PLAN AND PROFILE OF PROPOSED STATE HIGHWAY

PRINCE WILLIAM PARKWAY INTERCHANGE AT REALIGNED BALLS FORD ROAD

VDOT Proj.No.6234-076-266

Notice of Design Change (NDC) #02
JUNE 2021

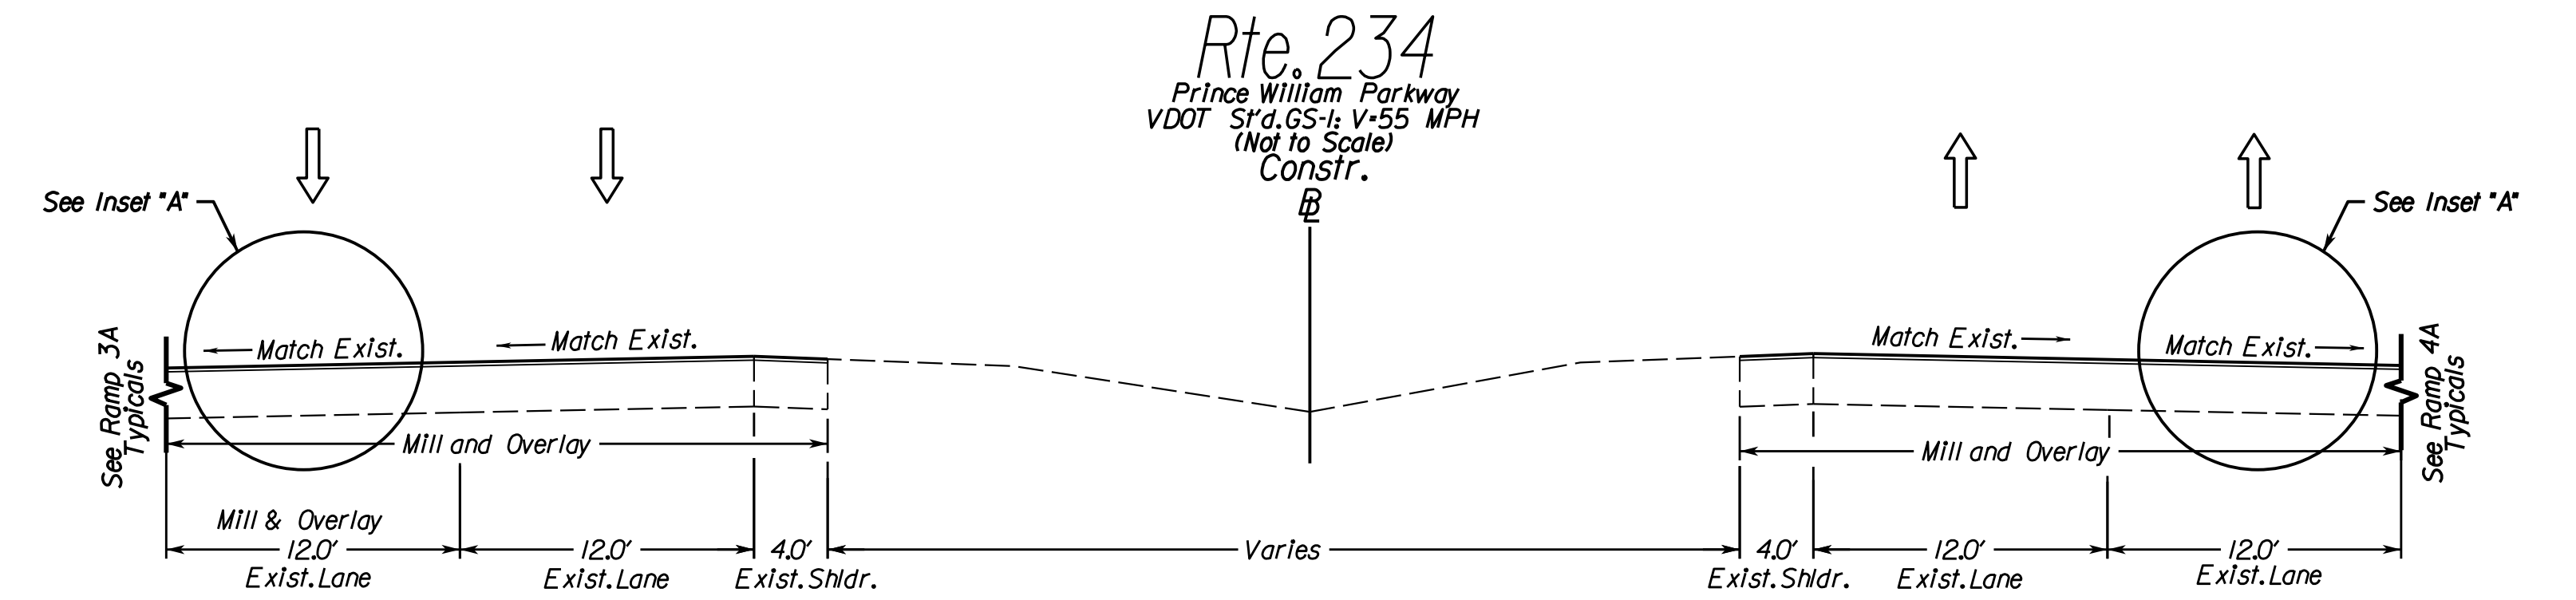
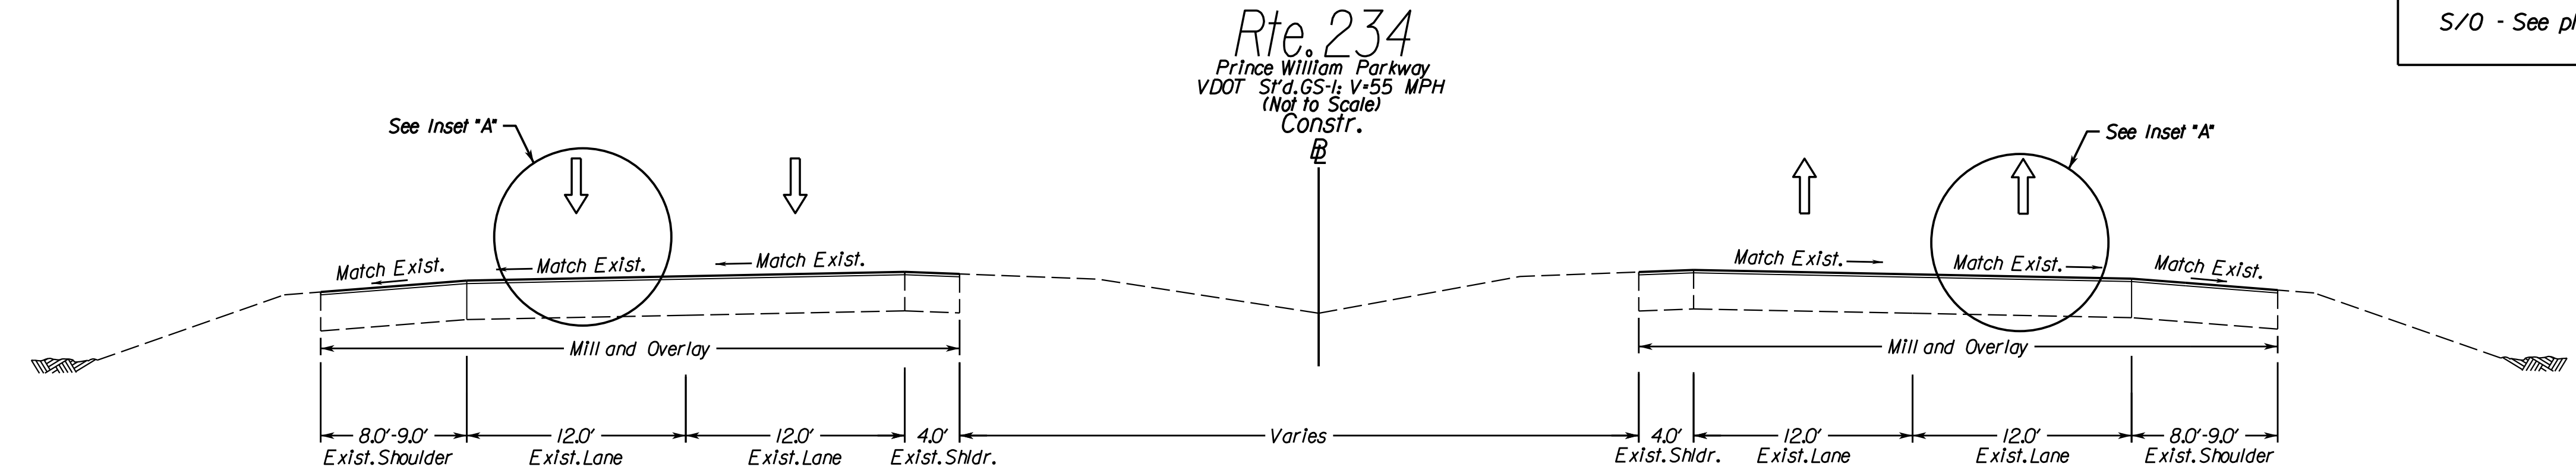
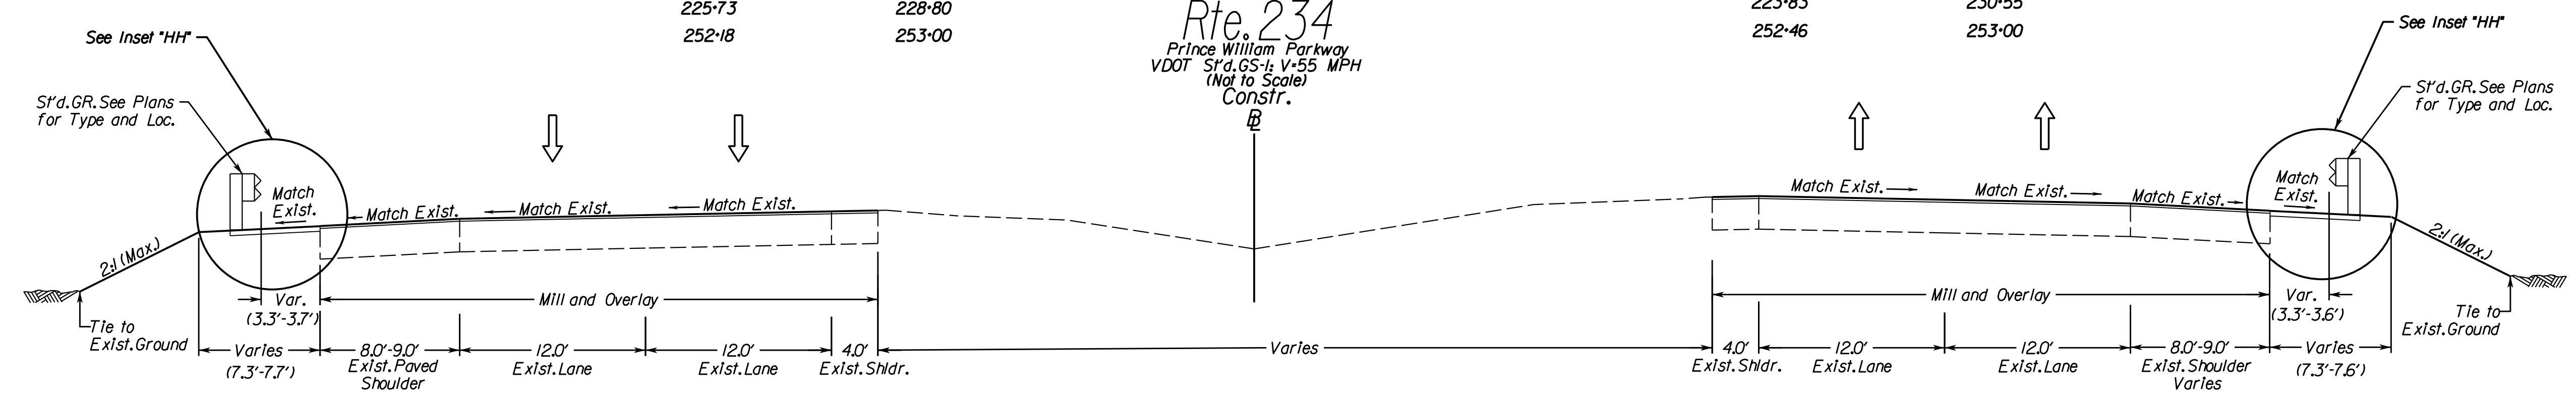
02 Revised shoulder section in pavement in front of BPPS.

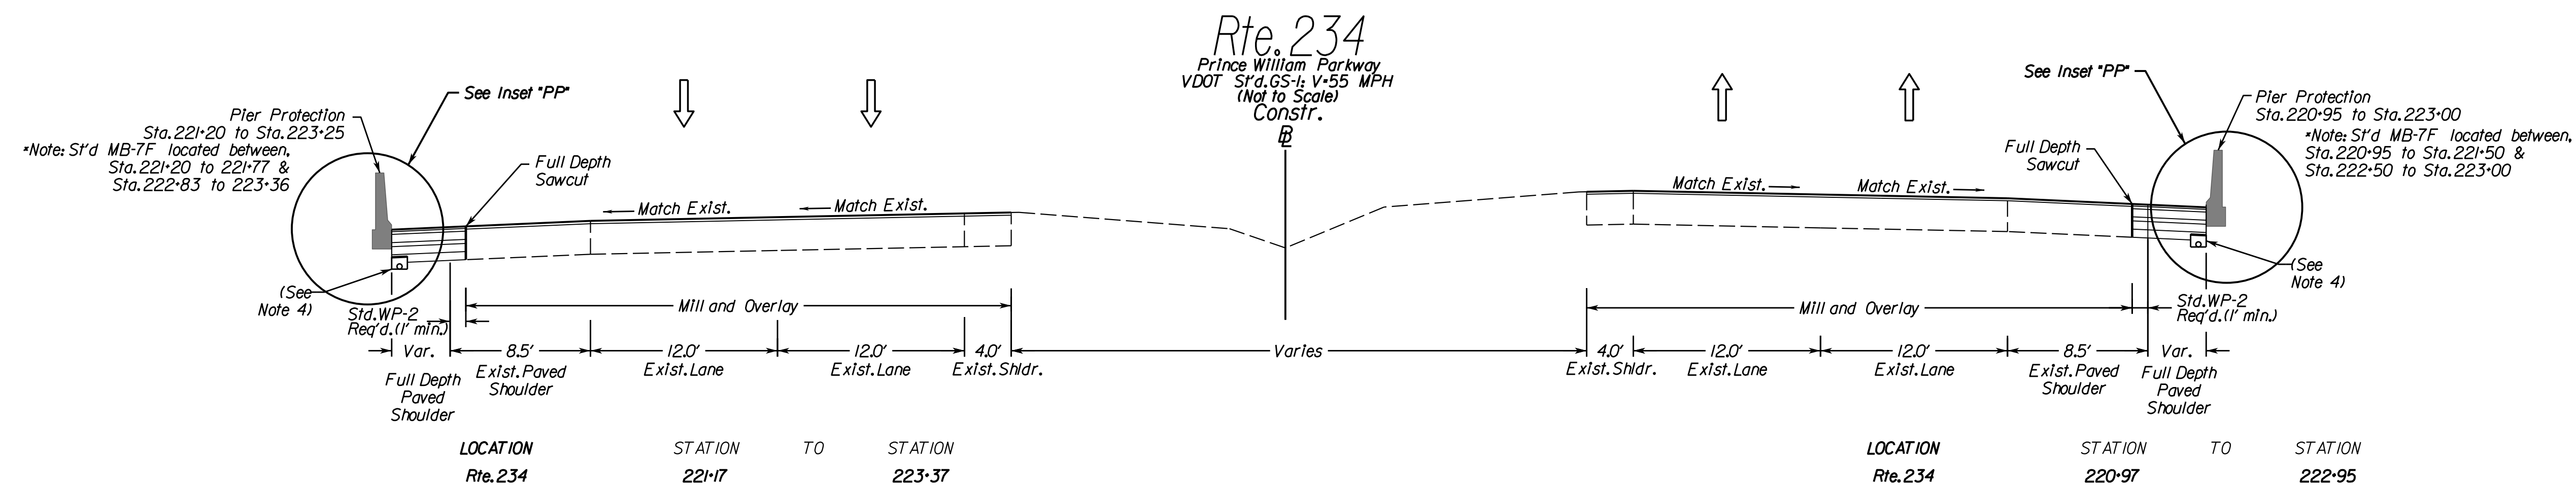
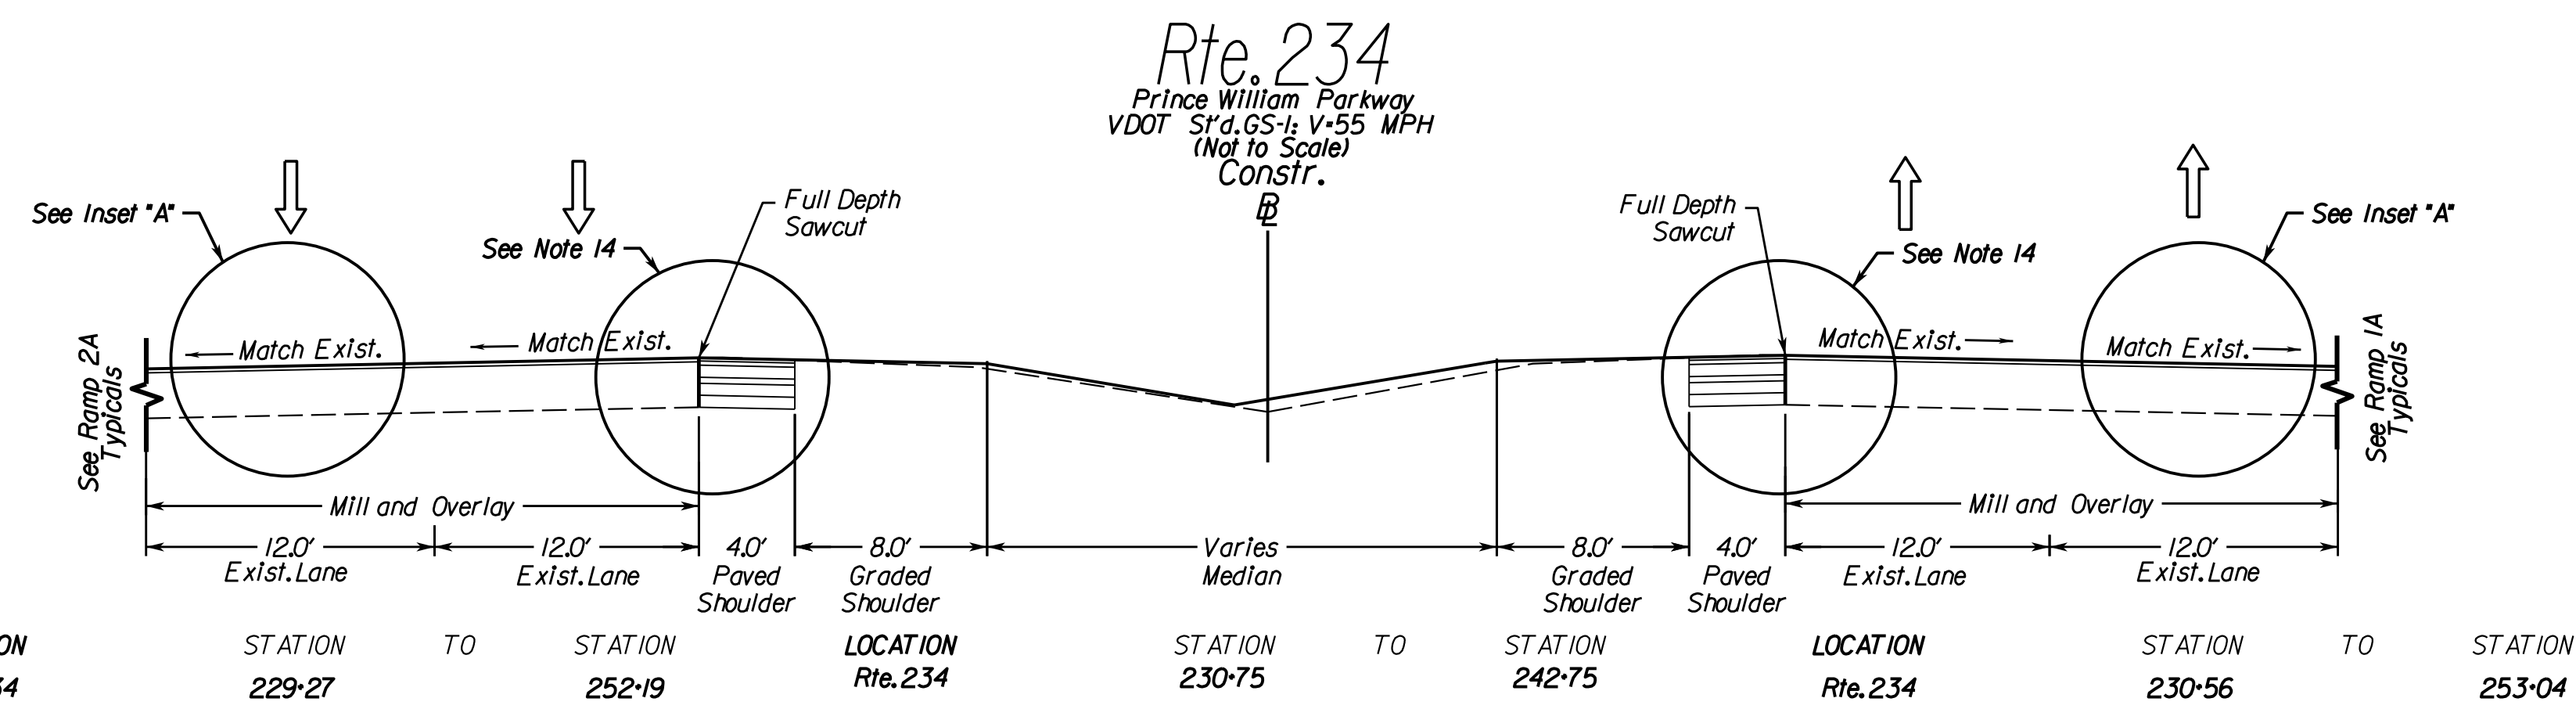
02 Revised shoulder section in pavement in front of BPPS.

Typical Sections Inset details

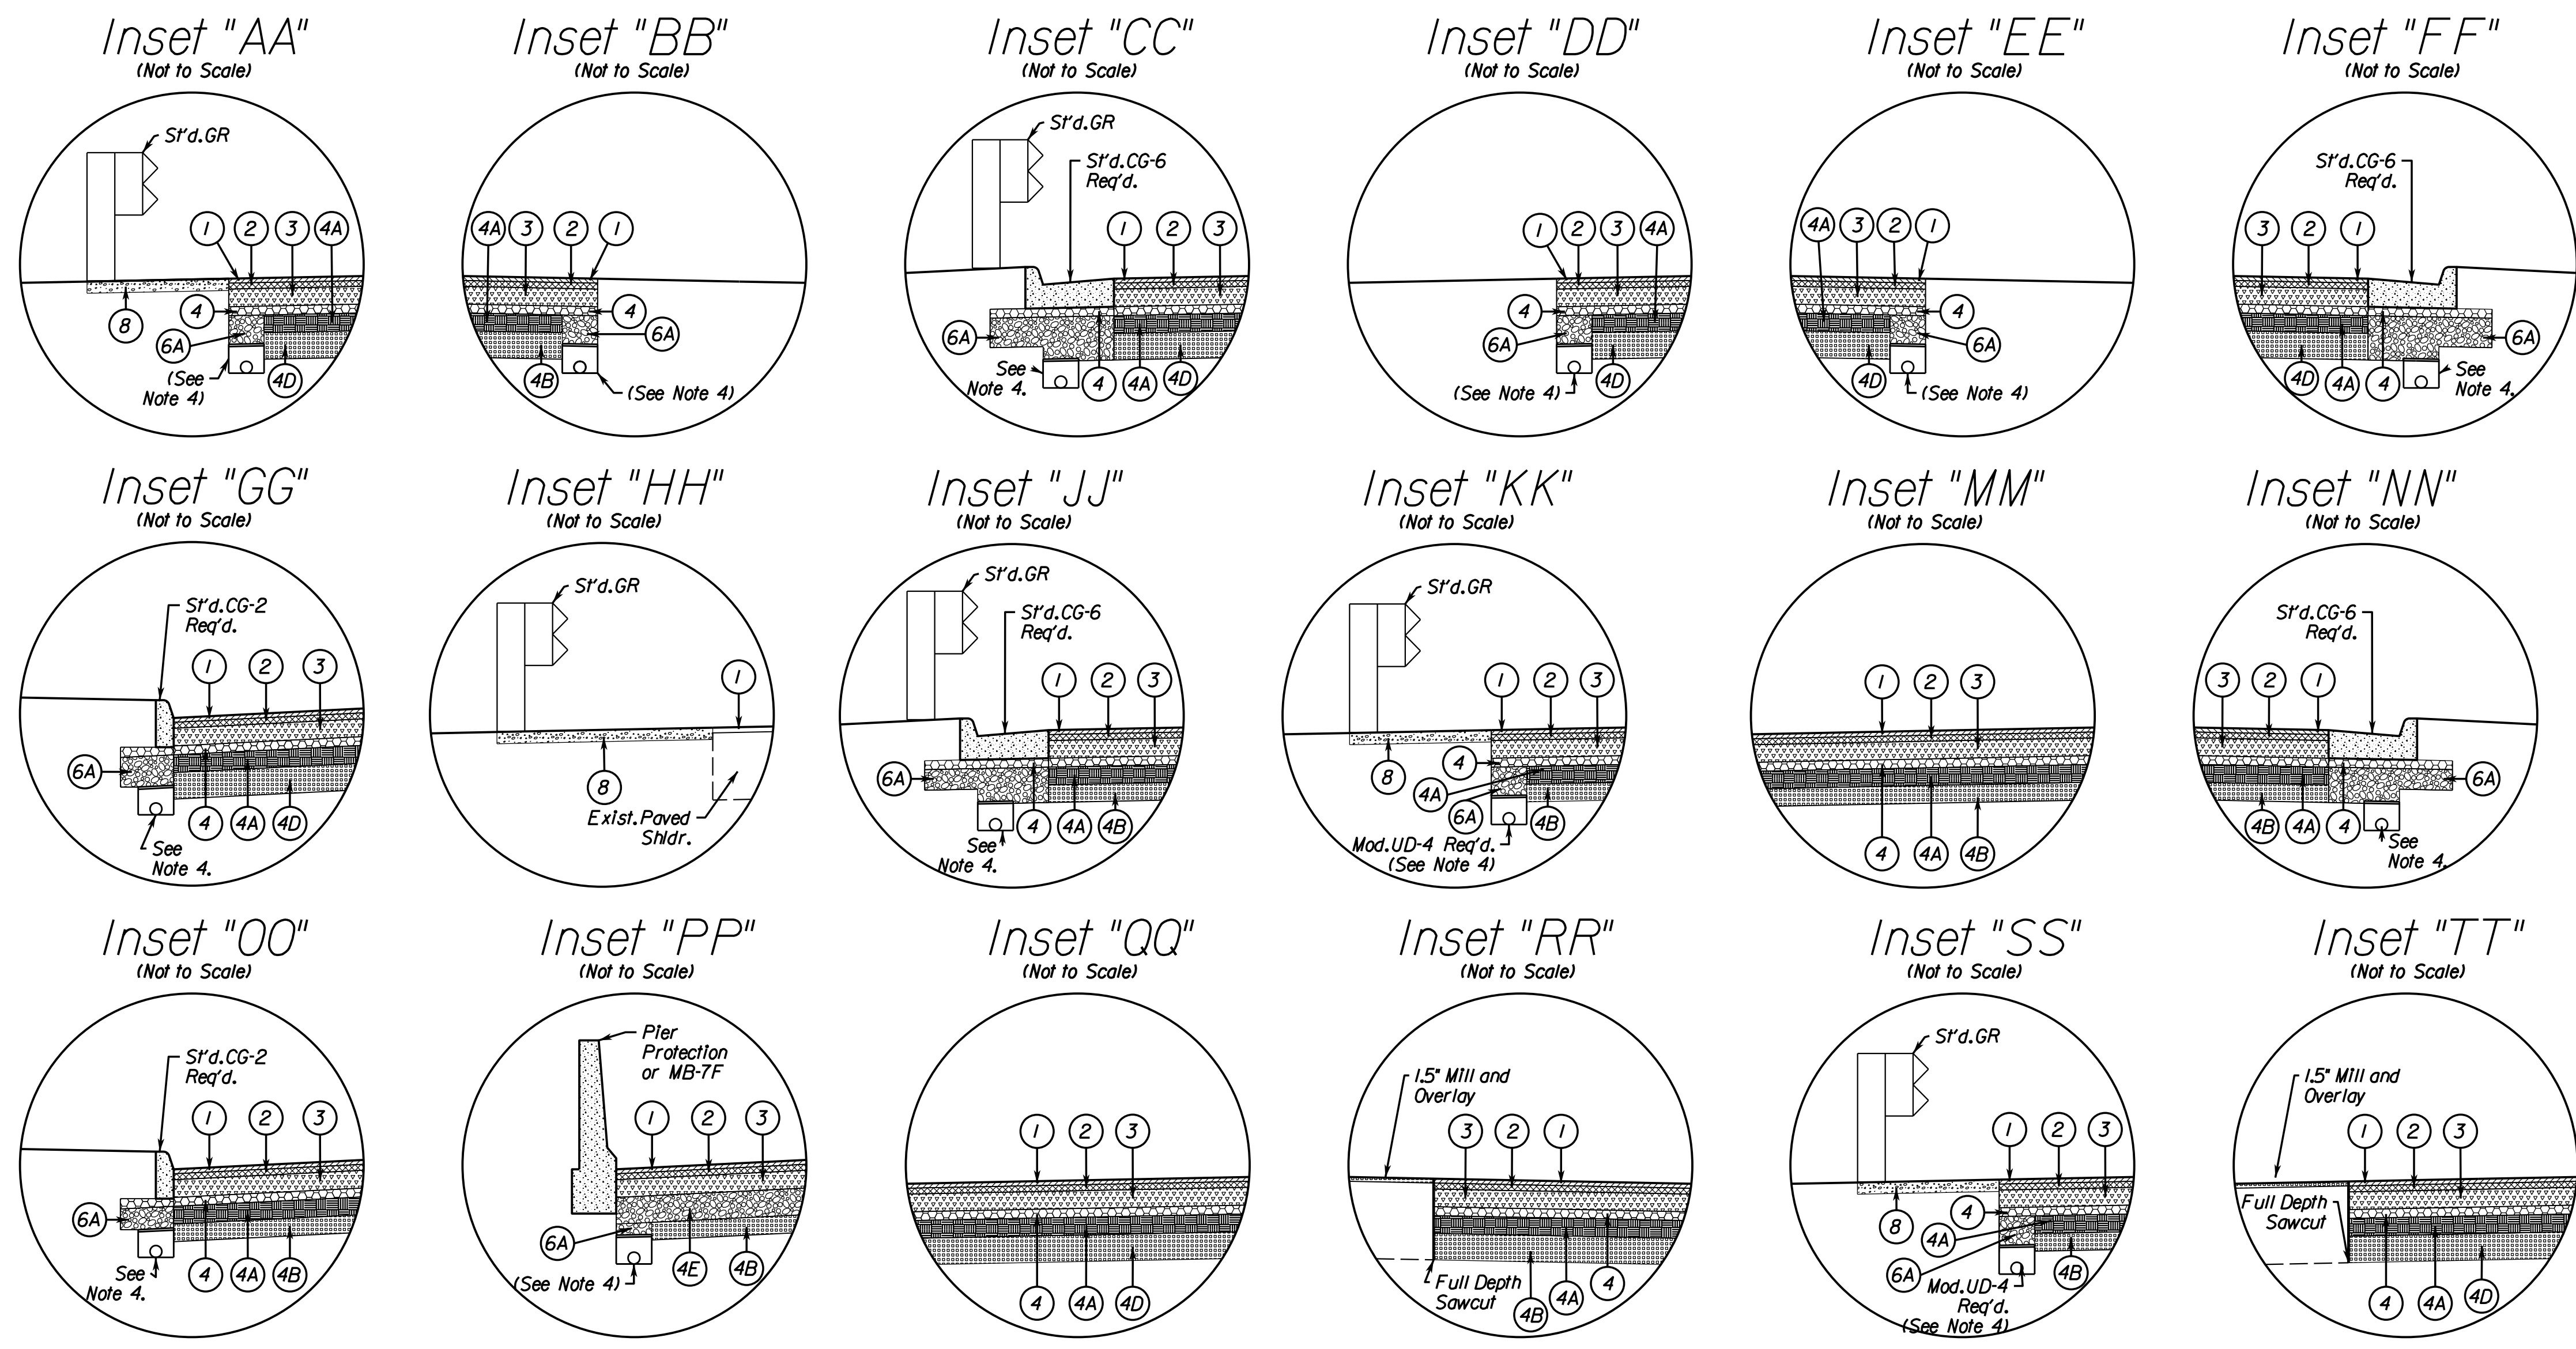
02 Revised shoulder section in pavement in front of BPPS.
